1435 - P095

Bedroom//Existing///Plan_1:20

Rev	Date	Notes
A	23.06.15	Radiator added and joinery removed .

Master Bathroom//Existing//Elevation 4_1:20

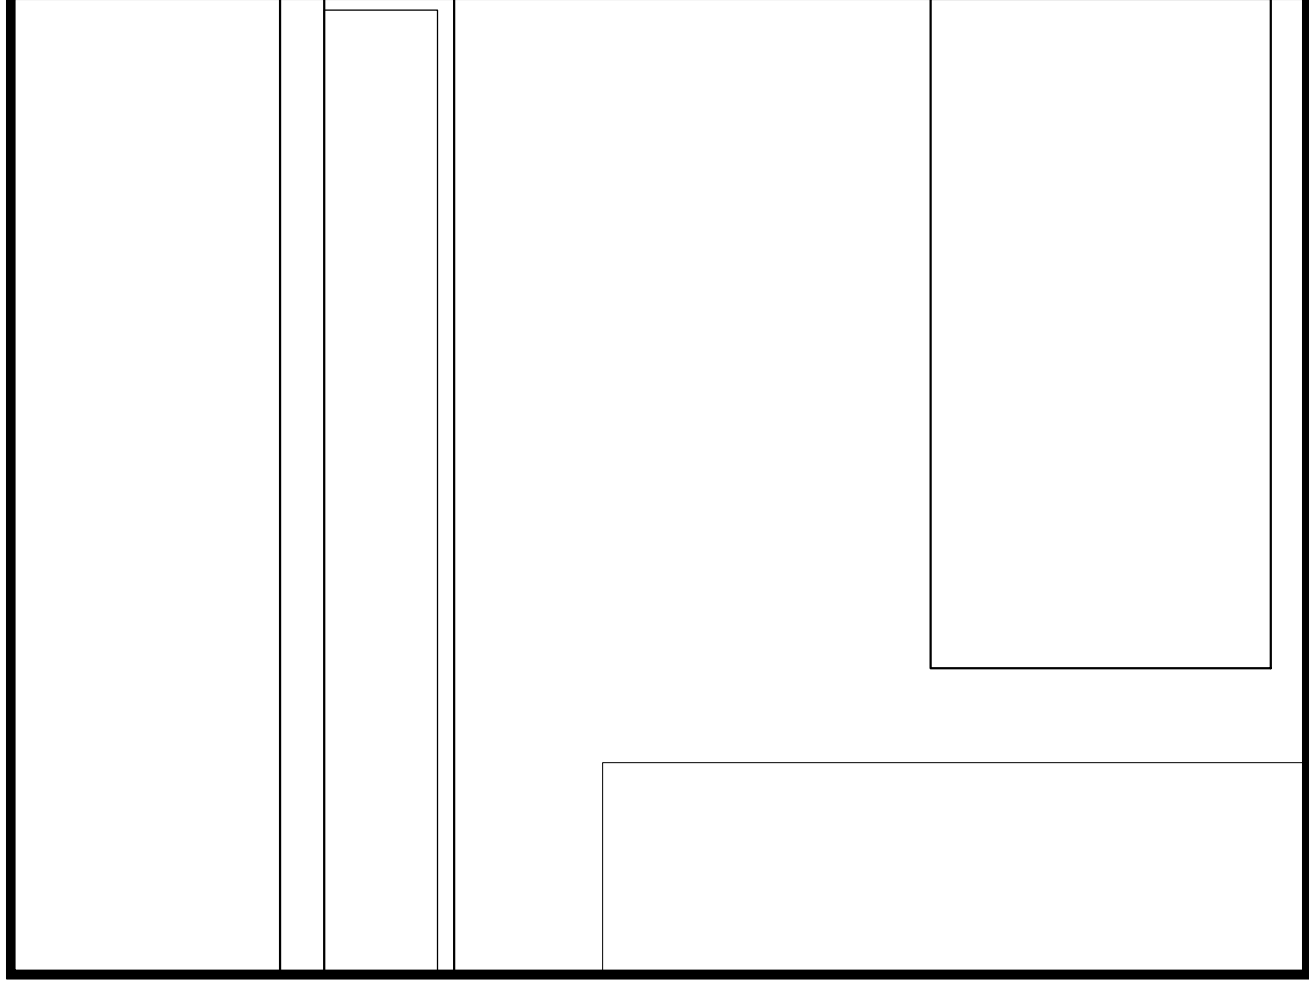
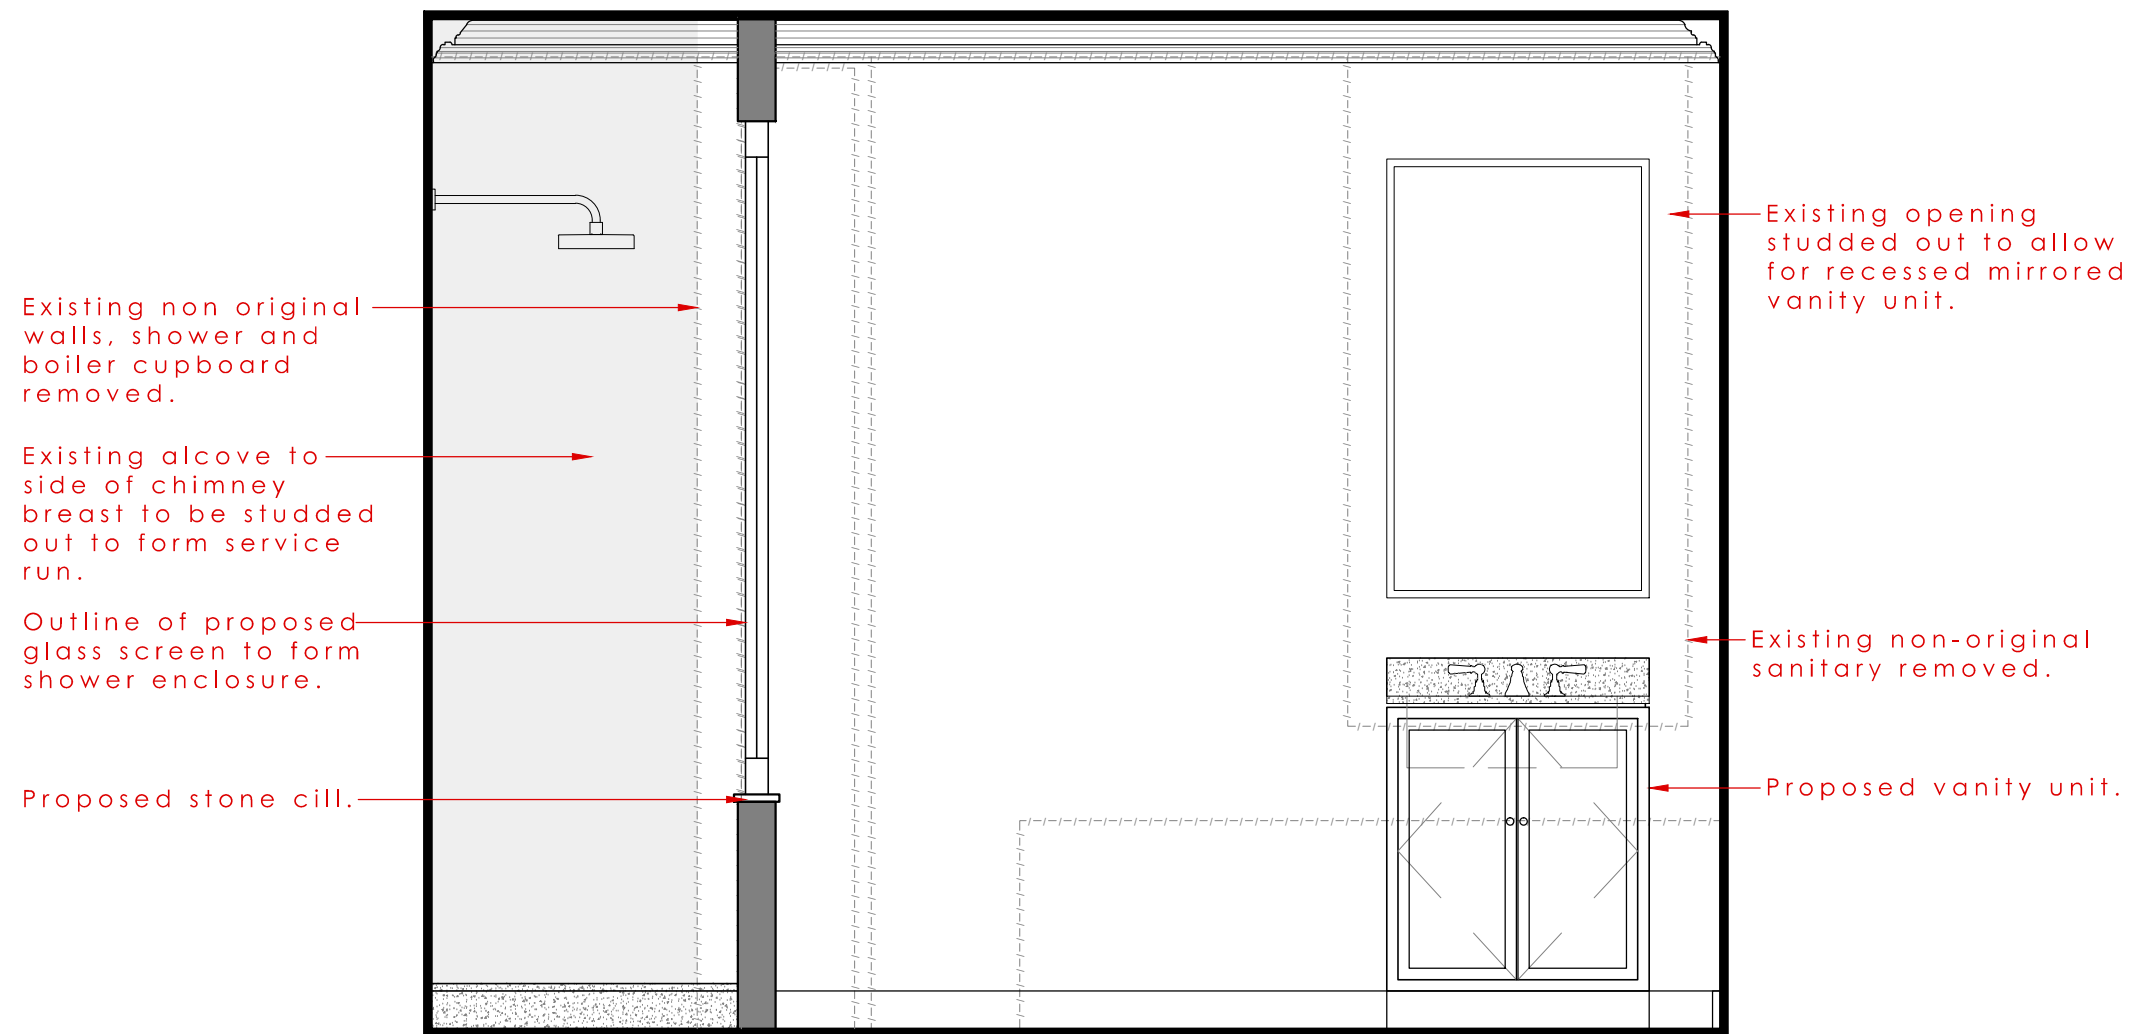
Rev	Date	Notes
A	23.06.15	Sanitaryware revised.

Elevation 1:20

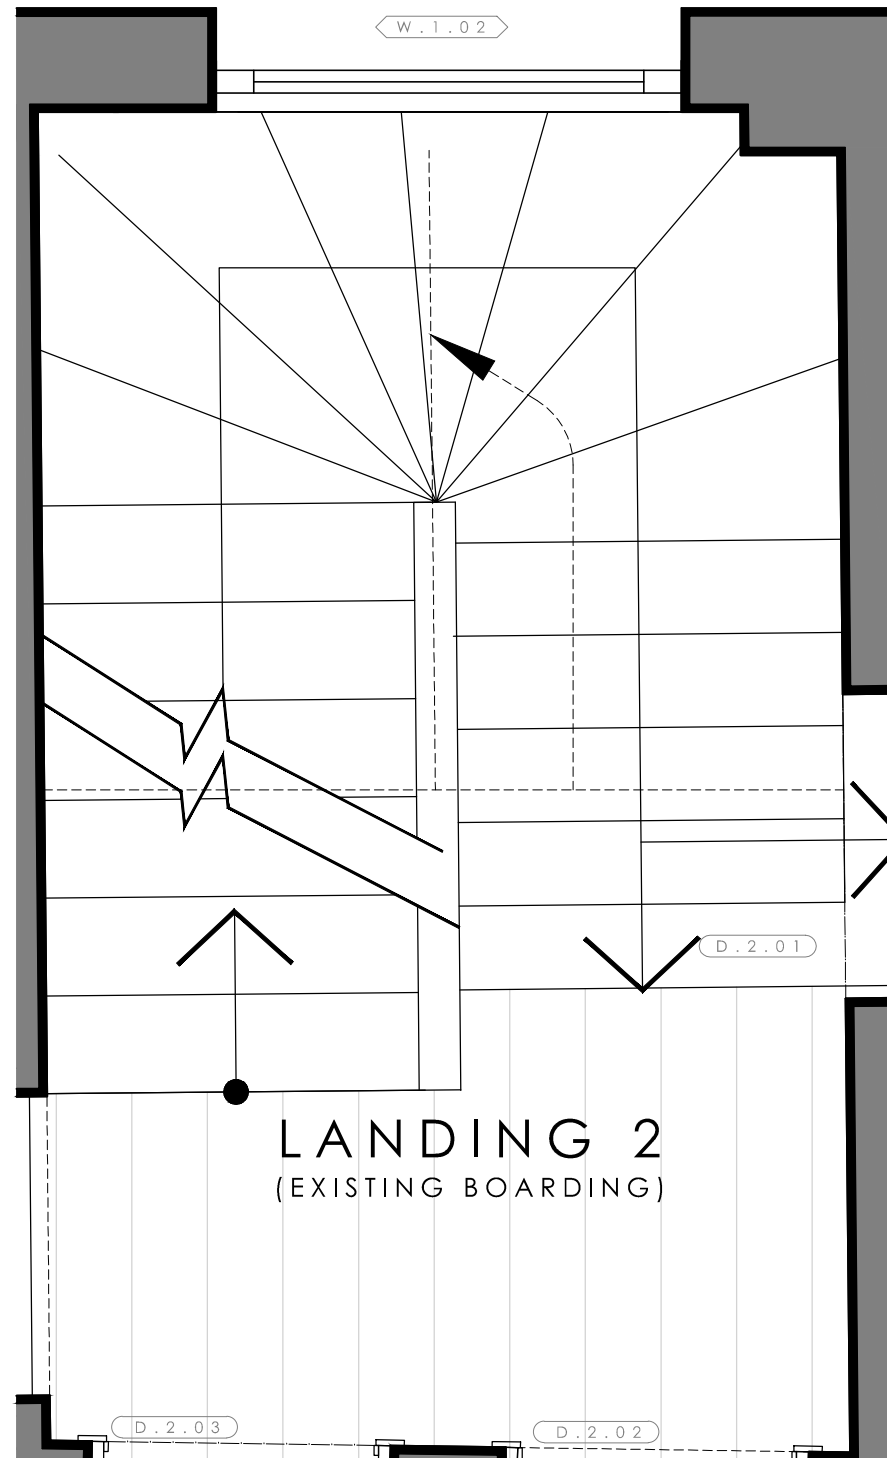
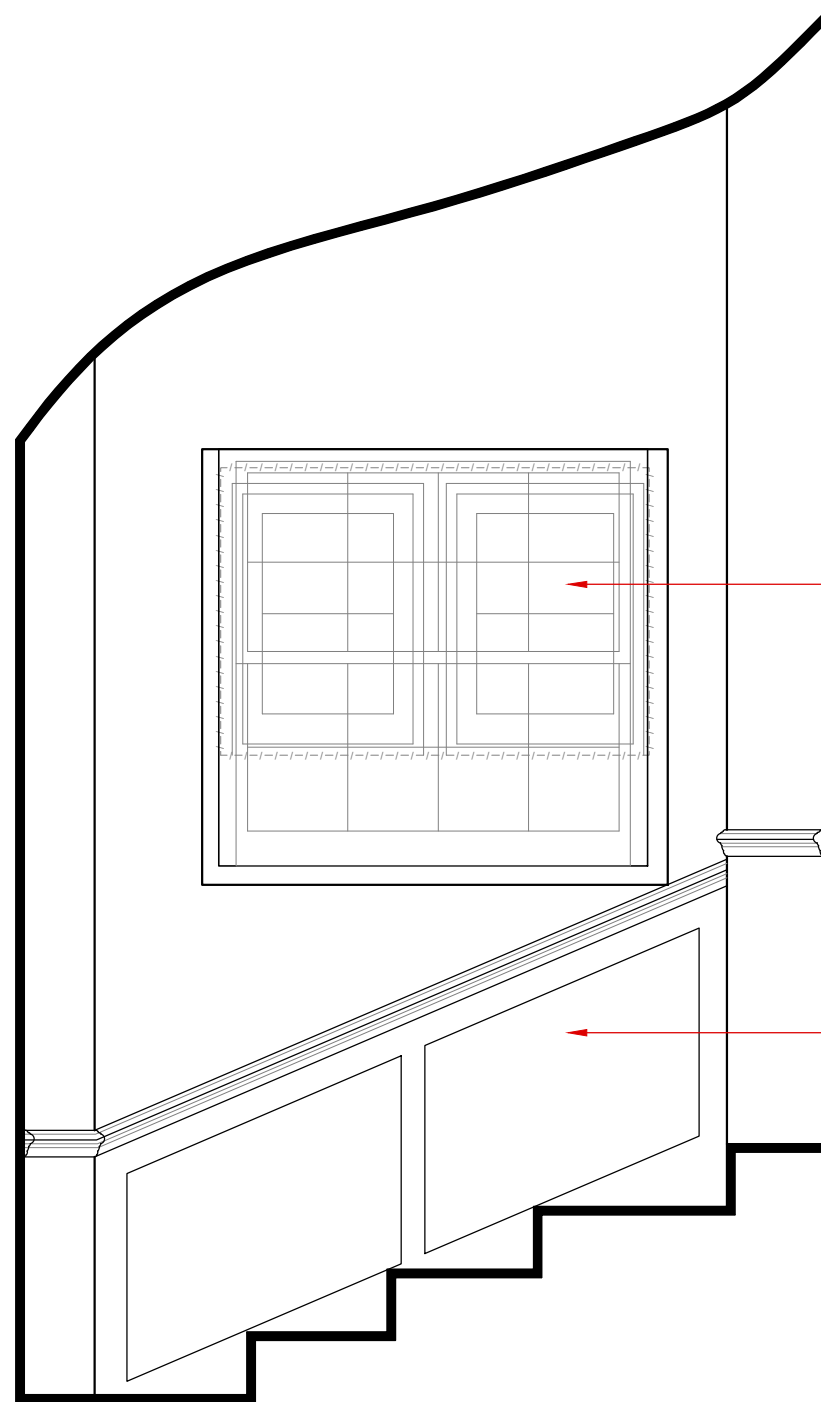
Existing window removed and sill lowered within existing larger opening. Proposed window to fill existing recess to panelling.

Existing panelling to remain as existing.
